NBSIR 80-2111-5

Review and Refinement of ATC 3-06 Tentative Seismic Provisions

Report of Technical Committee 5: Masonry

FIGURE 3

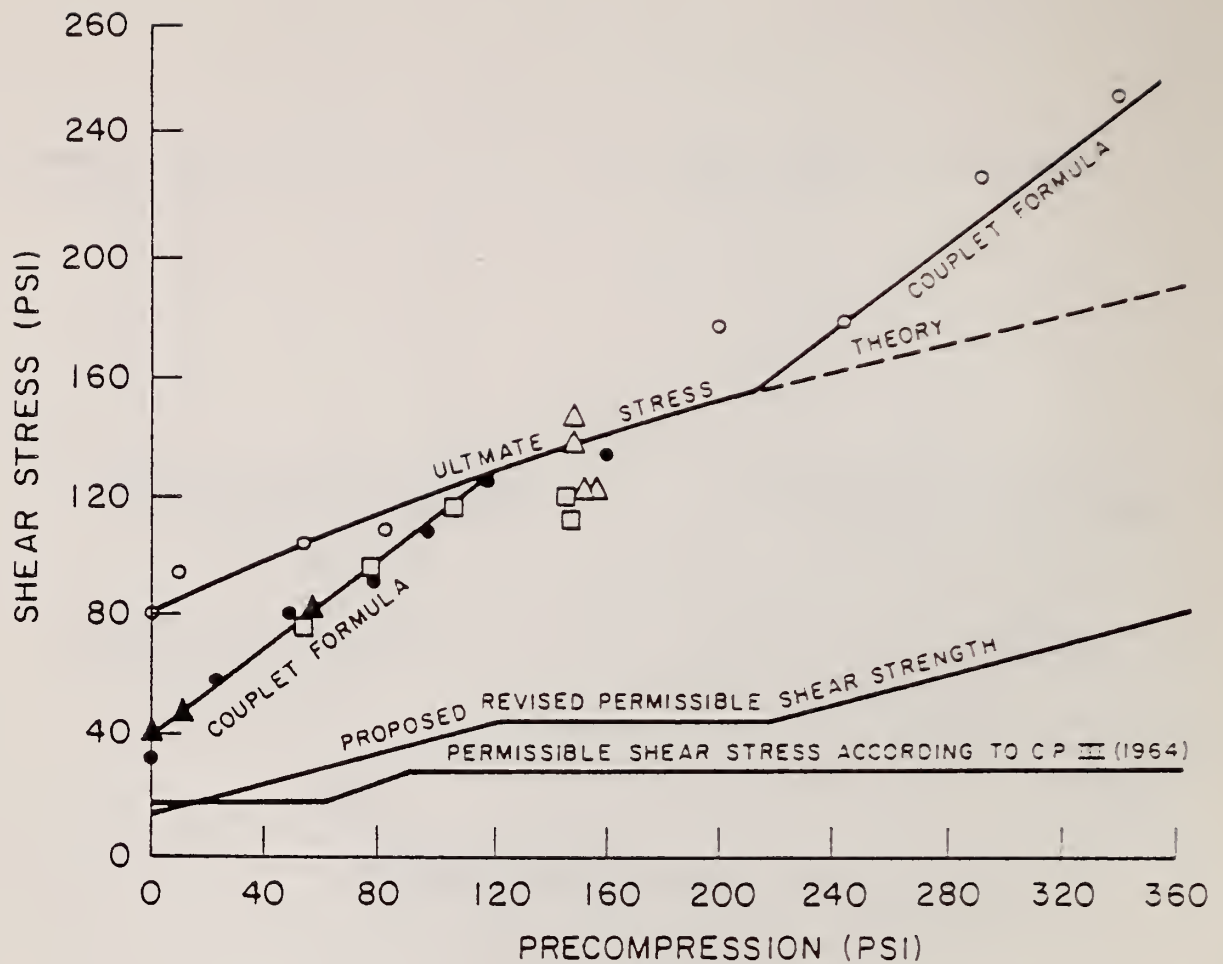
Before pursuing this further the validity of the results of the diagonal compression test shown in Figure 3 will be examined by comparing them with the results obtained from the Berkeley pier test program. At the last meeting Mr. Monk questioned the validity of performing this comparison because of the different stress states in the two test specimen. He correctly stated that regions 1 and 3 will have higher principal tensile stresses due to the combined affects of shear and bending tensile stresses

obtained from the diagonal compression test (Figure 3) is used as the basis for determining code allowables by applying a factor of safety to the test results. This in my view is an incorrect application of the test results. If this is pursued we should compare the shear stresses obtained from *the Berkeley* diagonal compression test and those obtained from the pier tests assuming there is no vertical load. These two values are obtained from the following two equations. For piers

The correct application, in my view is to work with the critical tensile stresses. Since this is not done in practical design its effect should be approximated in the application of the diagonal compression test results. The shear stresses obtained from the diagonal compression test should first be divided by 1.5 to account for the parabolic distribution of shear stress in a structural element. Some factor should then be applied to account for the variation obtained between the diagonal tension stresses of the piers σ_{tcr} and those of the panels σ_{tcr}^2 . From Figures 5 to 7 this would be somewhere between 0.5 and 0.7 say 0.6. Thus the shear stresses obtained from the diagonal compression test should be multiplied by $0.6/1.5=0.4$ before a factor of safety is applied. The factor of safety would then be applied to these reduced values to obtain an allowable shear stress that would be applicable to unreinforced masonry with no compressive load. If this methodology is applied to the results presented in the NCMA commentary where the average shear stress from the panel tests is given as 130 psi for type M and S mortar, the shear stress at failure with no compressive load would be $130 \times 0.4 = 52$ psi. Applying a factor of safety of 3 to this, the allowable shear stress would be 17 psi.

If this procedure is not followed then the upper limits for shear stress should be determined using the methodology recommended herein assuming there is no vertical load on the element. This would involve multiplying the shear stresses obtained from Figure 3 by 0.4 and then dividing these results by a factor of safety of say 3.

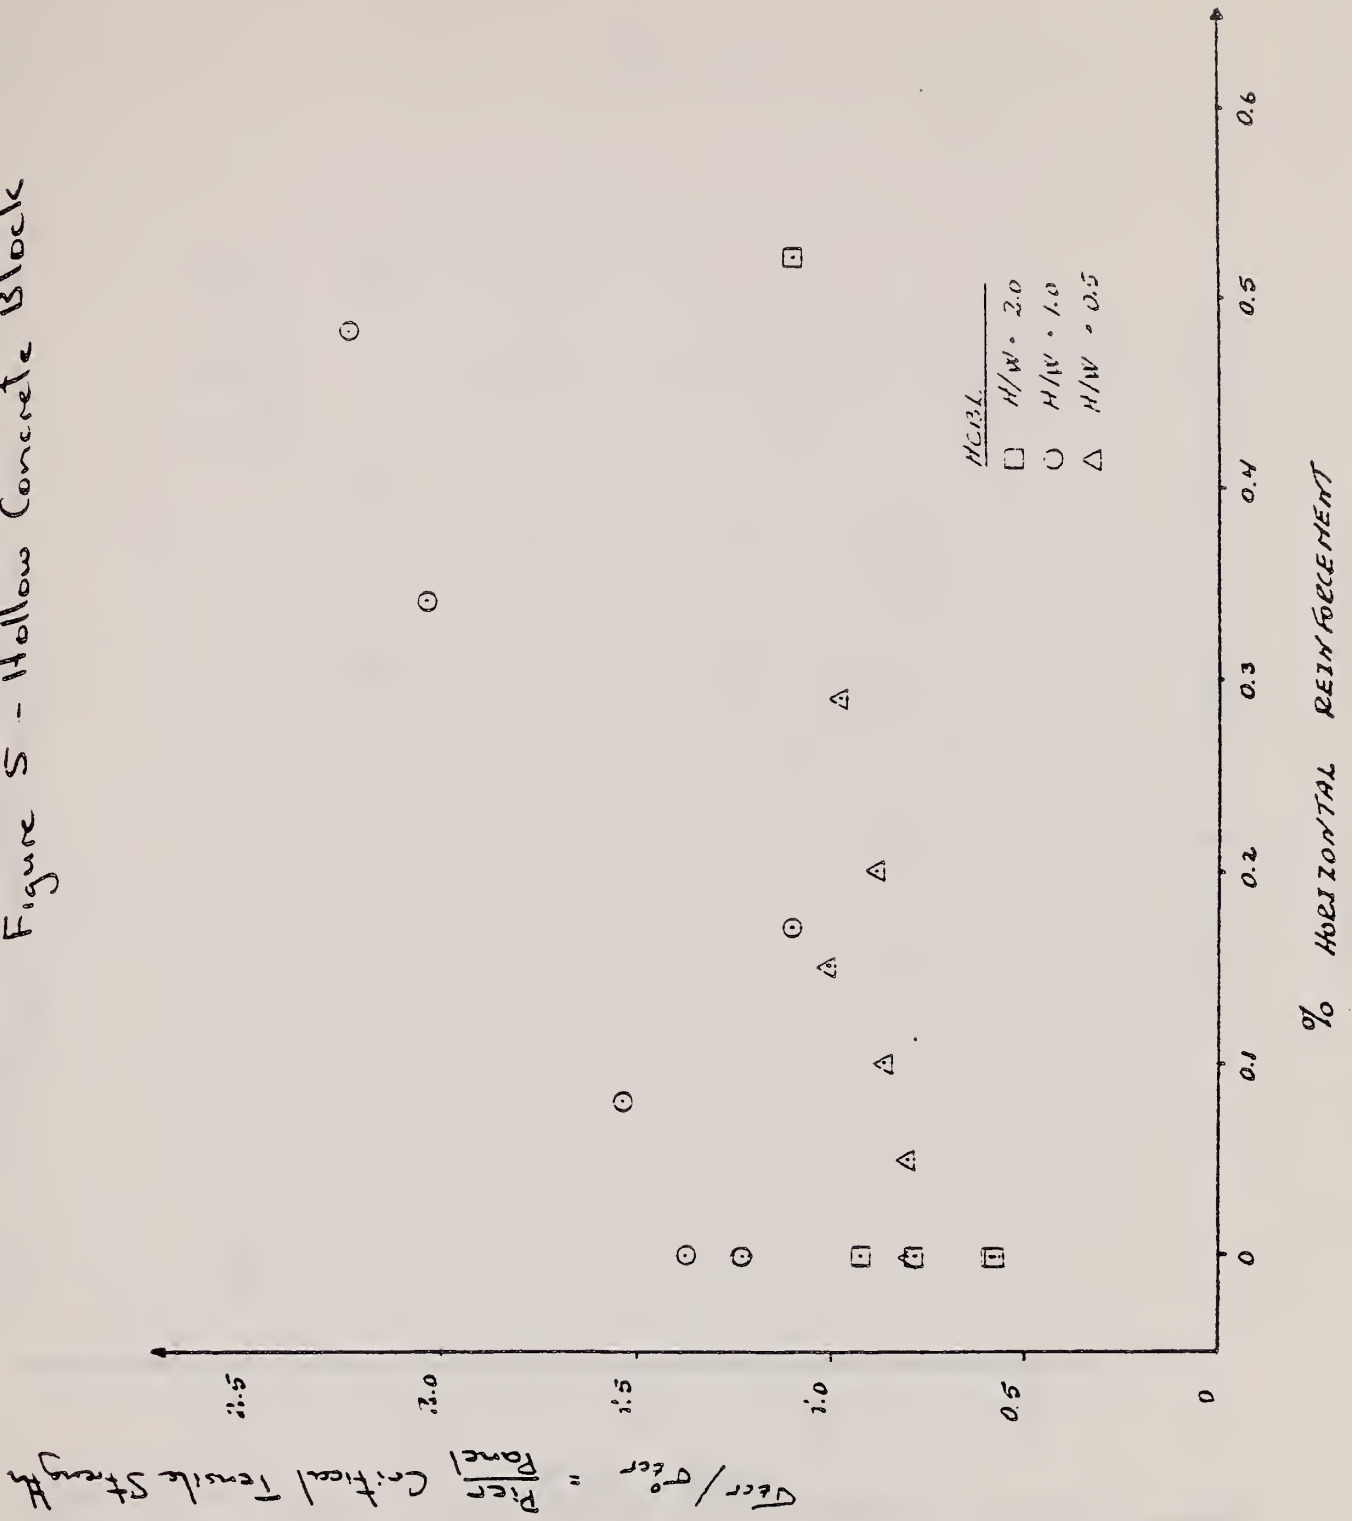
The English code for brick masonry has recognized these modes of failure for unreinforced brick masonry and a comparison of their proposed revision and test data is shown in Figure 4. The first sloping region of their proposed revision is governed by bond and friction between the mortar joints.

The proposed revision to the English code for brick masonry used a V_{bo} of 12 psi and a coefficient of friction of 0.25. The flat part of the allowable curve was at 42 psi.
